April 15, 2020

**Re: Request for Correction Under the Data Quality Act to NIST's Final Report on the Collapse of World Trade Center Building 7**

The information that is the subject of this Request is NIST's *Final Report on the Collapse of the World Trade Center Building 7* (NCSTAR 1A) and NIST's *Fire Response and Probable Collapse Sequence of World Trade Center Building 7* (NCSTAR 1-9), collectively referred to herein as the "NIST WTC 7 Report." Secondly, NIST's webpage titled *FAQs – NIST WTC 7 Investigation* (referred to herein as the "NIST WTC 7 FAQs") is also the subject of this Request. The NIST WTC 7 Report can be found at the following NIST webpage: <https://www.nist.gov/el/final-reports-nist-world-trade-center-disaster-investigation> (last visited April 14, 2020). The NIST WTC 7 FAQs can be found at the following NIST webpage: <https://www.nist.gov/topics/disaster-failure-studies/faqs-nist-wtc-7-investigation> (last visited April 14, 2020).

**Figure 1–5. Typical WTC 7 floor showing locations of the columns, girders, and beams.**

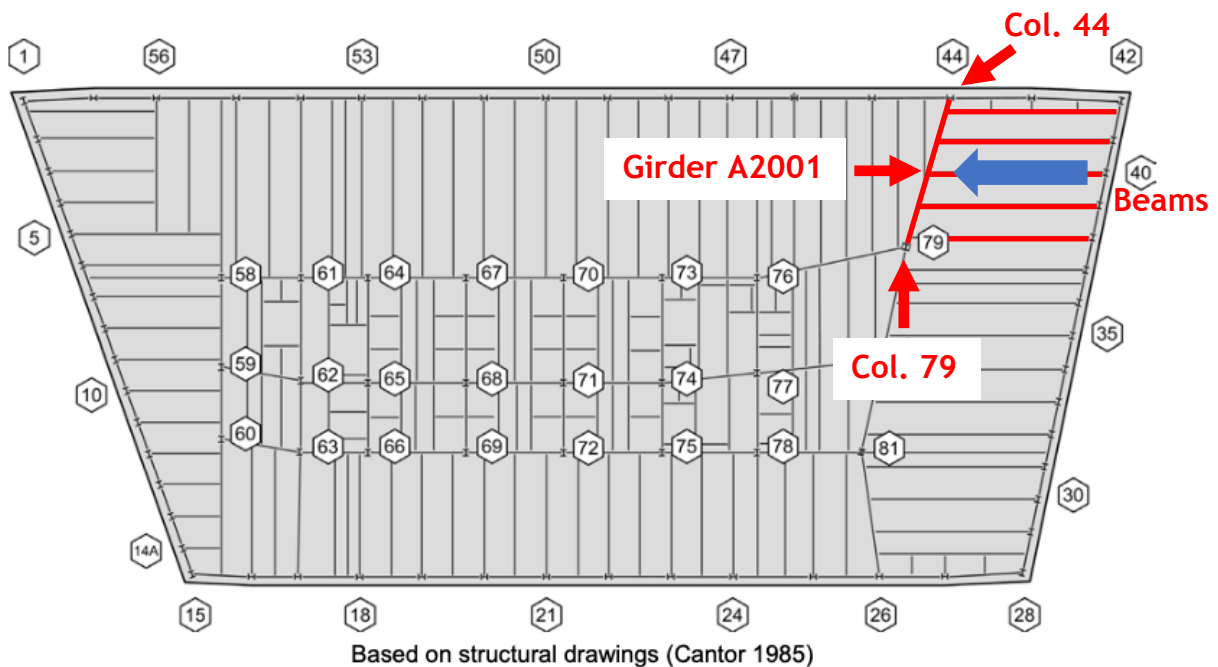
case, the floor beams on the east side of the building expanded enough that they pushed the girder spanning between Columns 79 and 44 to the west on the 13th floor. (See Figure 1–5 for column numbering and the locations of girders and beams.) This movement was enough for the girder to walk off of its support at Column 79.

The structural elements mentioned above are shown below in Figure 1.5 of NCSTAR 1A. The blue arrow indicates the westward direction in which, according to NIST, the floor beams thermally expanded and caused the girder (Girder A2001) to walk off its support at Column 79.

**Figure 8–21. Seat connection at Column 79.**

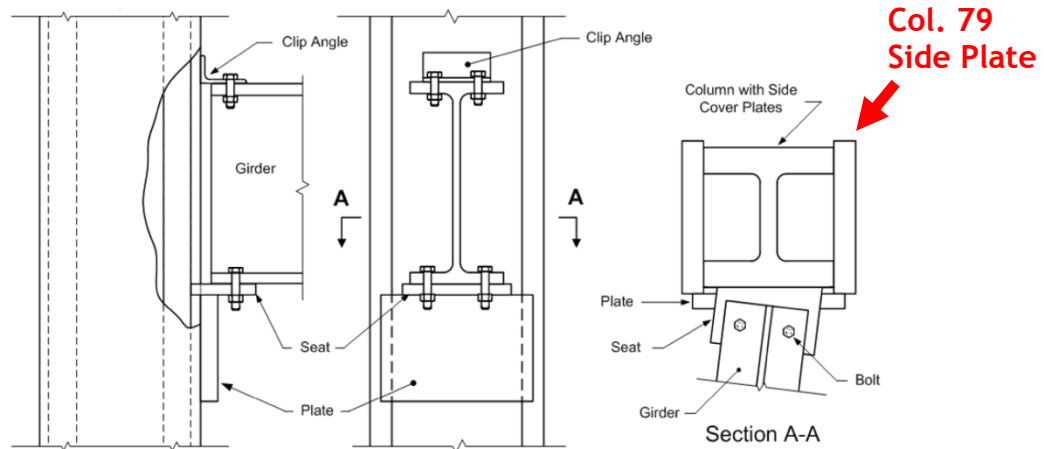
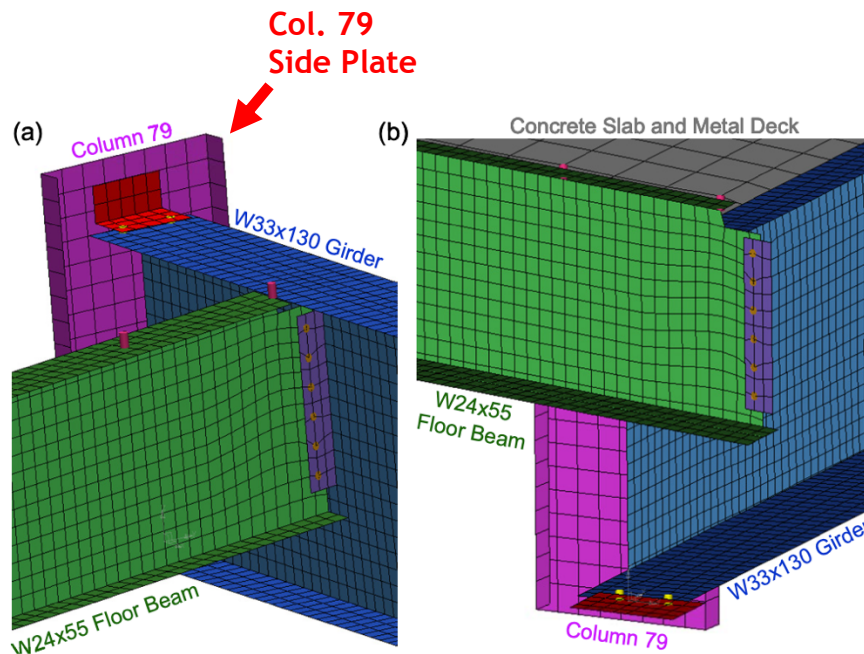
Column 79 was a W14 x 730 standard structural shape column with 2” x 26” built-up side plates welded to its flanges at Floor 13. Column 79 and its side plates are pictured in Figures 8-21 and 8-23 of NCSTAR 1-9, shown below, with the western side plate pointed out. The dimensions of the side plates are given in the fabrication shop drawings. (See Frankel Steel Limited, Drawing 1091.)

- a) **Revise the NIST WTC 7 Report to Reflect that the Column 79 Side Plate Would Have Prevented Girder A2001 from Moving Westward Enough to Walk Off Its Support at Column 79**

First, NIST must revise the NIST WTC 7 Report to reflect that the Column 79 side plate would have prevented Girder A2001 from moving westward enough to walk off its support at Column 79. Alternatively, if NIST maintains that Girder A2001 was able to move past the Column 79 side plate, it must amend the NIST WTC 7 Report to include analysis that satisfies the objectivity, utility, transparency, and reproducibility standards of information quality.

Figure 8–26. Lateral displacement of girder due to thermal expansion of floor beam. Note: failed bolts and shear studs

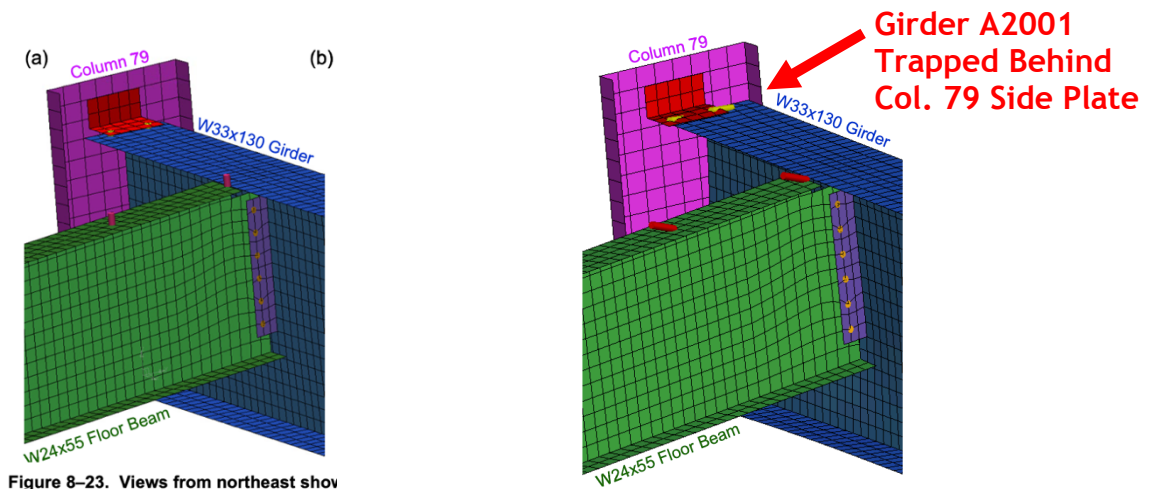
. . . Continued axial expansion of the floor beams pushed the girder laterally at Column 79, as shown in Figure 8–26, in which failed shear studs and bolts were evident. . . . **Continued axial expansion of the girder caused it to bear against the face of Column 79**, generating large axial forces that led to failure of the bolts connecting the girder to Column 44. (Emphasis added.)

The trapping of Girder A2001 behind the Column 79 side plate in NIST’s preliminary LS-DYNA analysis is illustrated graphically in Figure 8-26 of Section 8.8 shown below. Juxtaposing Figure 8.23 (left) with Figure 8.26 (right) illustrates the westward travel of Girder A2001.

Figure 3.4 Plan view showing girder A2001 trapped by the Column 79 side plate.

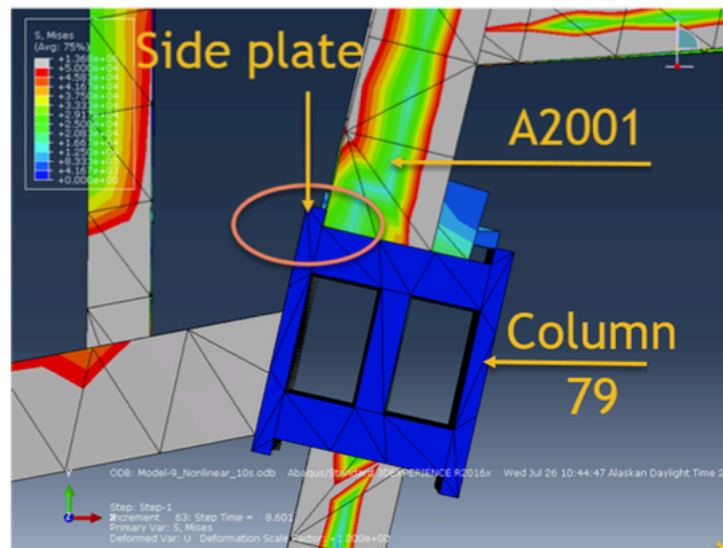
First, we found that when girder A2001 is heated, it expands such that it becomes trapped behind the side plate on the western side of Column 79 as it is pushed to the west by thermally expanded beams K3004, C3004, B3004, A3004, and G3005 (see Figure 3.4). . . .

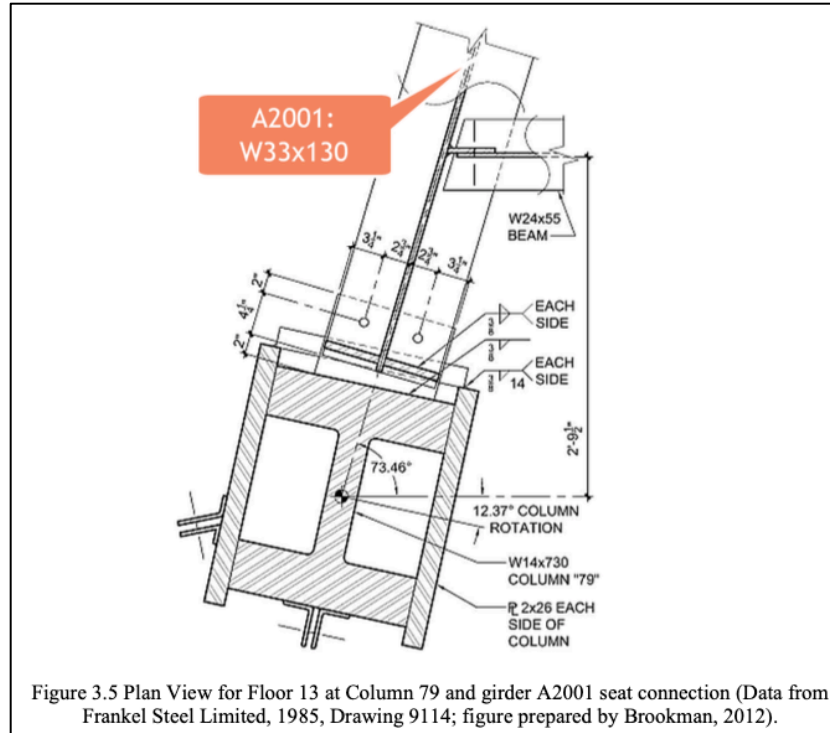
. . . Figure 3.5 [shown below] shows the girder bearing seat at Column 79 is 12 inches wide. The flange width for W33 x 130 girder A2001 is 11.510 inches wide and centered on the seat; its web is 0.580 inches thick. **This would require a lateral travel distance of 6.290 inches for the web to be beyond the seat.** However, the distance between the column side plates is 17.89 inches. **The girder and bearing seat are slightly off center to the east, with just 3.678 inches between the girder's western edge and Column 79's western side plate. Thus, the side plate prevents the girder's web from traveling beyond the bearing seat.** (Emphasis added.)

**Figure 10–39. Computed temperature distribution (°C) on the floor beams of Floor 13 at 12 different instants in time (Case B, floor slabs removed).**

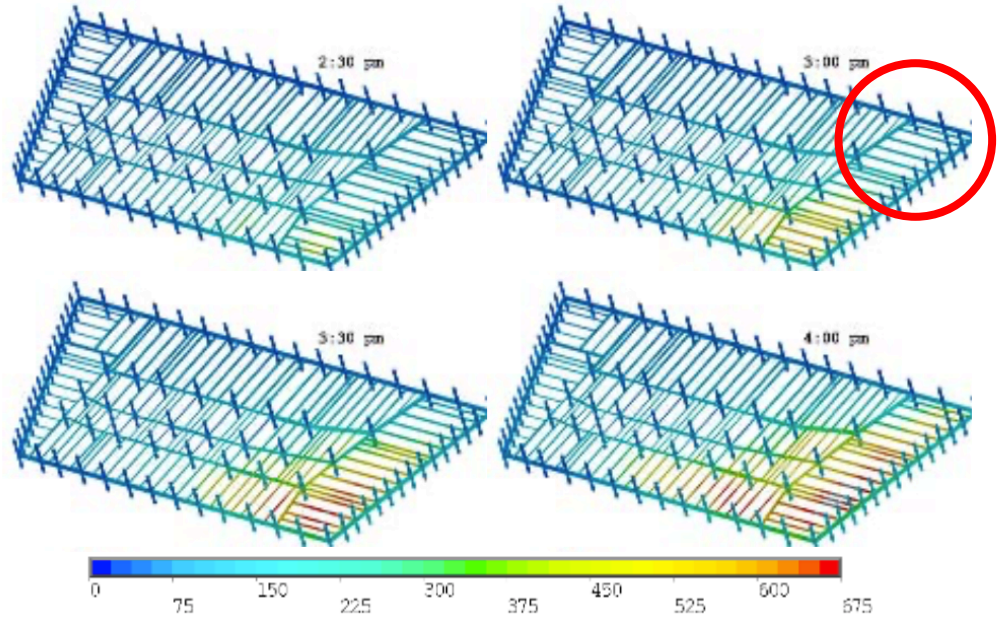
The Case B floor temperatures used in NIST’s 16-story ANSYS model are somewhat difficult to decipher in Figure 10-39 below. (The Case B floor temperatures are the computed worst-case scenario temperatures, which NIST then used in its global collapse analyses.) Nevertheless, careful review indicates that the temperatures of Girder A2001 and the floor beams to its east were approximately the same until at least 3:30 PM, and that Girder A2001 reached temperatures 164 °C (enough for it to move within the envelope of the Column 79 side plate) long before the floor beams to its east were heated sufficiently to push Girder A2001 to the west at least 3.678 inches. Focusing on beam K3004, which was the closest beam to Column 79 framing into Girder A2001, and thus dictated the extent of westward displacement of Girder A2001 at Column 79, the thermal expansion from room temperature length would be only 2.527 inches at 300 °C and would not reach 3.700 inches until 430 °C (based on NIST’s Coefficient of Thermal Expansion (CTE) value for steel of  $1.4 \times 10^{-5}$  in/in-°C, and the room temperature (20 °C) length of beam K3004 of 644-11/16 inches).

**Girder A2001 Is Heated to at Least 164°C Long Before Floor Beams Are Sufficiently Heated to Push It 3.678 Inches to the West**

### a) Revise the NIST WTC 7 Report to Reflect that Beam K3004 Could Not Thermally Expand Enough to Cause the Walk-Off of Girder A2001

First, NIST must revise the NIST WTC 7 Report to reflect that beam K3004 could not thermally expand enough to cause the walk-off of Girder A2001. Alternatively, if NIST maintains that beam K3004 was able to thermally expand enough to cause the walk-off of Girder A2001, it must amend the NIST WTC 7 Report to include analysis that satisfies the objectivity, utility, transparency, and reproducibility standards of information quality.

**Figure 1-5. Typical WTC 7 floor showing locations of the columns, girders, and beams.**

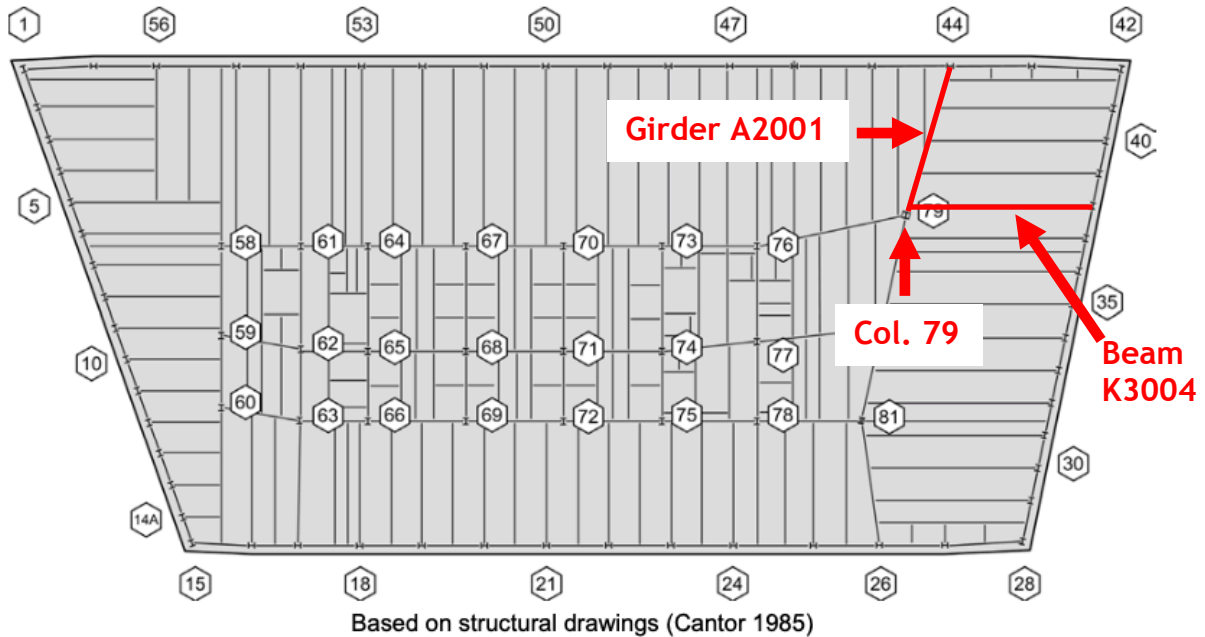
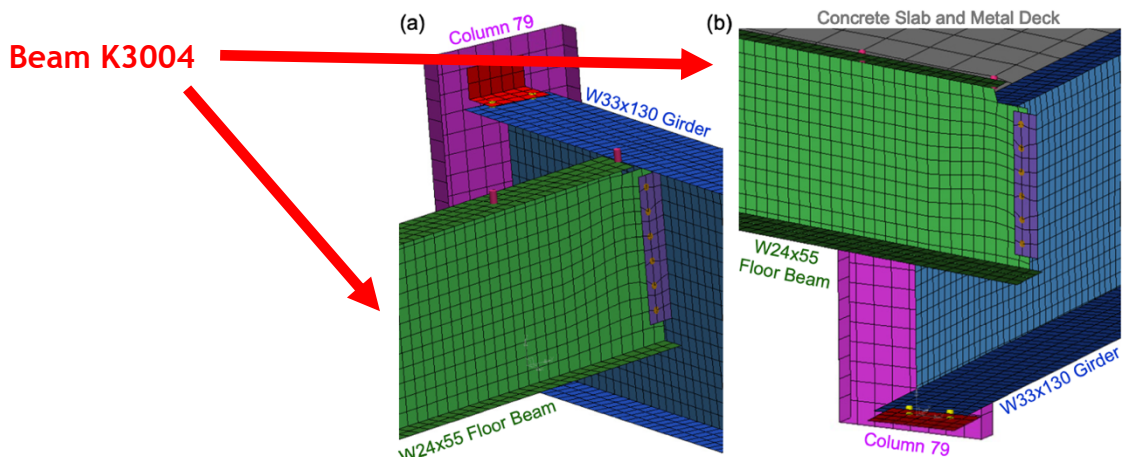
As noted above, beam K3004 was the closest beam to Column 79 framing into Girder A2001 from the east. Therefore, the thermal expansion of beam K3004 dictated the extent of westward displacement of Girder A2001 at Column 79. Beam K3004 is indicated in Figures 1-5 and 8-21 of NCSTAR 1-9 below.

Figure 2: Section View at Floor 13, Column 79 Seated-Beam Connection  
(Data from Frankel Steel Limited, 1985b)

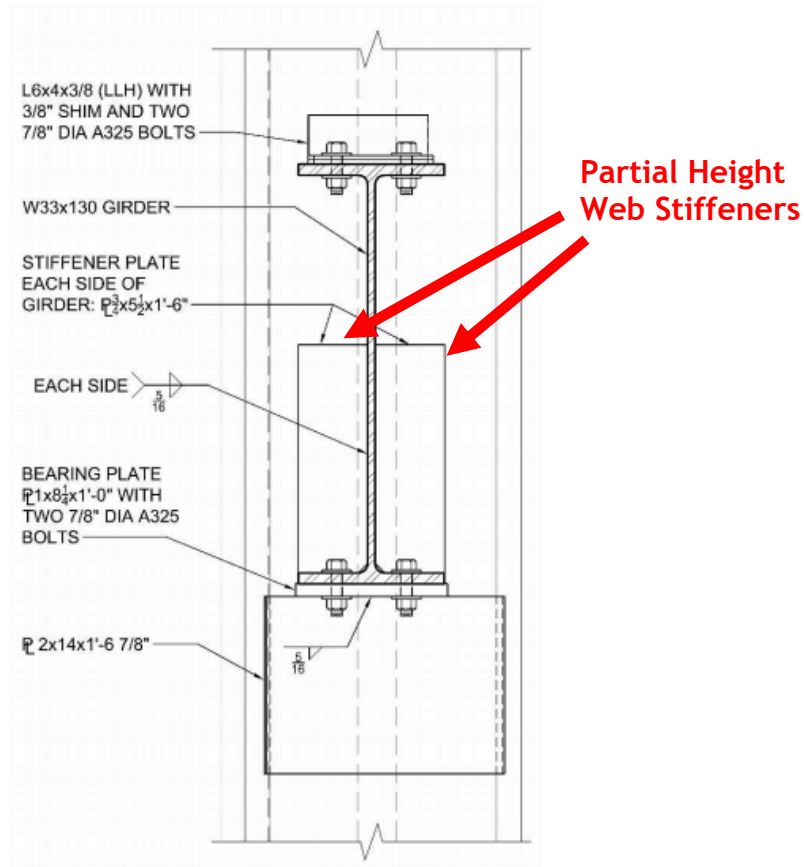
Girder A2001 had partial height web stiffeners measuring 3/4 inches thick x 5.5 inches wide x 18 inches high, as indicated in fabrication shop drawing Frankel 9114. (See Frankel Steel Limited.) These web stiffeners are drawn to scale in Figure 2 of Ronald Brookman's 2012 paper, "A Discussion of 'Analysis of Structural Response of WTC 7 to Fire and Sequential Failures Leading to Collapse'," shown below. (See Brookman 2012, p. 8.)

NIST, however, omitted these web stiffeners from its analyses. The omission of these web stiffeners is evident in Figure 8-21 of NCSTAR 1-9 (shown in the previous section) and was also confirmed via email on October 25, 2013, by NIST public affairs officer Michael Newman, who wrote (*see Exhibit C*):

### a. **Perform New Analyses that Includes the Web Stiffeners on Girder A2001 and Revise the NIST WTC 7 Report to Reflect that Girder A2001 Would Not Have Walked Off Its Support at Column 79**

First, NIST must perform new analyses that include the partial height web stiffeners on Girder A2001. There is no reasonable basis for not performing these new analyses since NIST has acknowledged it omitted the web stiffeners from its analyses, and this omission has been shown to have materially affected the results of NIST's analyses. NIST must then revise the NIST WTC 7 Report to reflect that Girder A2001 would not have walked off its support at Column 79. Alternatively, if NIST maintains that Girder A2001 was able to walk off its support at Column 79 despite the presence of the web stiffeners, it must amend the NIST WTC 7 Report to include analysis that satisfies the objectivity, utility, transparency, and reproducibility standards of information quality.

Figure 3.8 Analysis showing girder web A2001 pushed laterally past the bearing seat at Column 79. The column is removed for clarity.

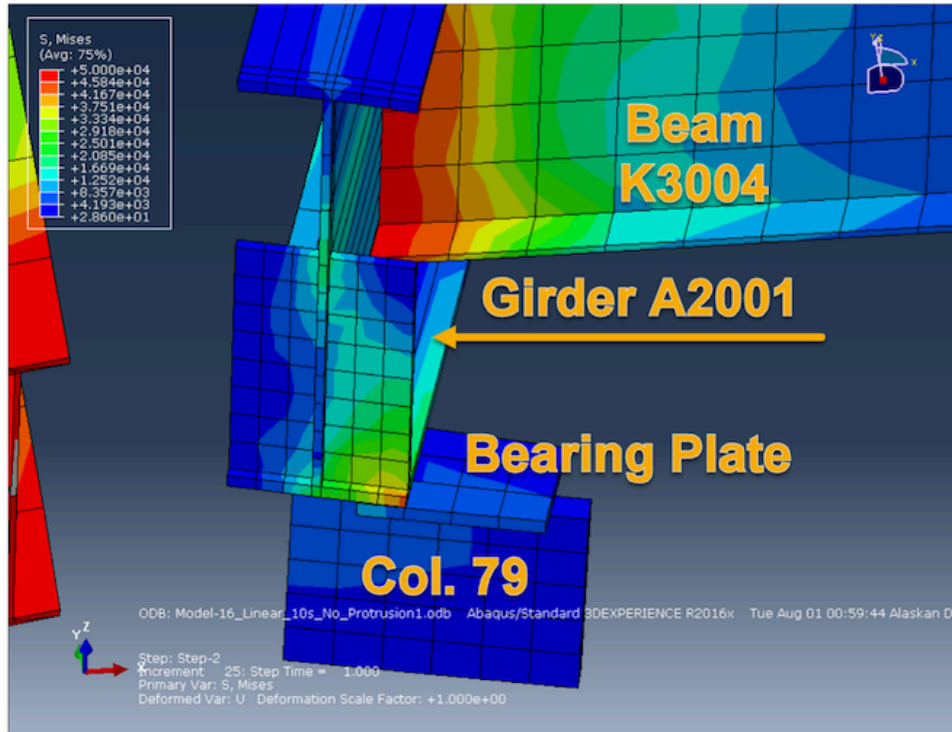
NIST's stated reason for omitting the web stiffeners from its analyses is fundamentally unsound. As noted in the UAF Report, "In addition to stiffening the web, these stiffeners significantly increase the bending resistance of the flange and would have prevented it from failing due to flexure (assuming the girder were somehow able to bypass the column side plate)." (*See UAF Report*, p. 81.) As illustrated in Figure 3.8 of the UAF Report, shown below, the stresses in the girder flange and stiffener are not sufficient to cause the flange to fail, and thus Girder A2001 would not have walked off its support at Column 79 when pushed westward 6.25 inches. (*See UAF Report*, p. 82.)

Figure 3.15 The relevant 0.52 Hz mode of the falling beam and girder assembly.

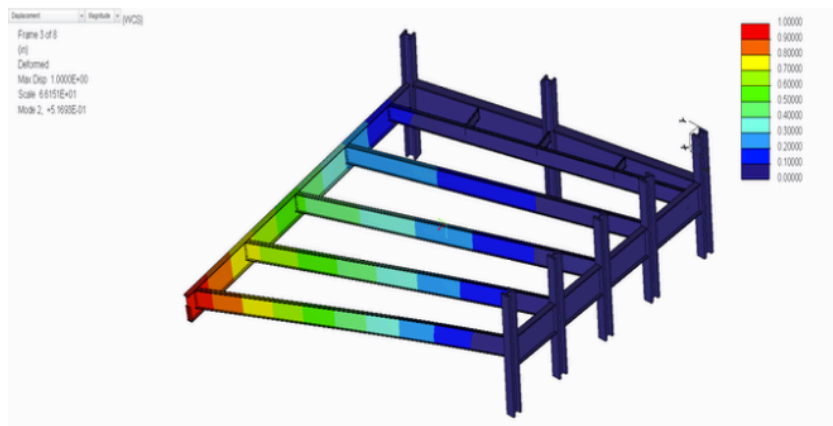
To determine the stiffness of the falling Floor 13 beam and girder assembly, a finite element modal analysis was performed with the assembly constrained at the north and east exterior walls and the girder sitting on its bearing seat at Column 44 with the bolts at the girder seat broken there. The results are shown in Figure 3.15. The first mode of 22 Hz involved only the beams moving in a transverse direction and was not relevant. The second mode of 0.52 Hz involved the participation of the entire beam and girder assembly in the vertical direction and was relevant.

a. **Revise the NIST WTC 7 Report to Include Calculations that Demonstrate that the Impact Load of Floor 13 Falling onto Floor 12 Would Be Insufficient to Cause Floor 12 to Fail**

First, NIST must revise the NIST WTC 7 Report to include calculations that demonstrate that the impact load of Floor 13 falling onto Floor 12 would be insufficient to cause Floor 12 to fail. Alternatively, if NIST maintains that the impact load of Floor 13 falling onto Floor 12 was sufficient to cause Floor 12 to fail, it must amend the NIST WTC 7 Report to include analysis that satisfies the objectivity, utility, transparency, and reproducibility standards of information quality.
